1964 TEMPEST

SYNCHRO-MESH TRANSMISSION COVERS

Fig. 1

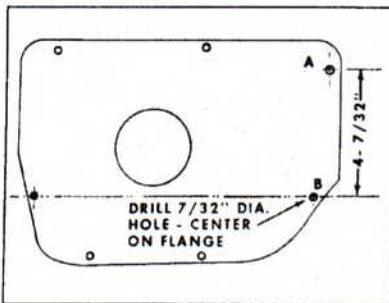
1964 Tempests built before October 7, 1963, with a 3 or 4 speed synchro-mesh transmission and console, or a 4 speed floor shift, used a screw at "A" Fig. 1 to attach the transmission shift control cover to the floor pan. See Fig. 7-11, 1964 Tempest Chassis Shop Manual. However, this rearmost screw is located directly over the propeller shaft and under certain conditions the shaft can hit the screw resulting in a damaged propeller shaft.

Therefore, all subject cars should be inspected for this condition and reworked at the earliest opportunity.

1. Remove those parts necessary to perform steps 2, 3 and 4.

2. Remove screw at "A" and fill hole with body sealer.

3. Drill a 7/32" diameter hole on the center of the flange at "B" Fig. 1.

4. Install screw and sealer at "B".

Fig. 2

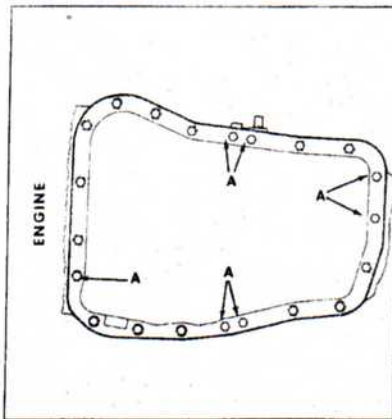
An additional pan bolt with a copper washer has been added to the 375 Hydra-Matic transmission. Place the bolts with copper washers in locations "A" as shown in Fig. 2. This information supersedes that on page 7C-84, Figure 7C-139, 1963 Pontiac Chassis Shop Manual.
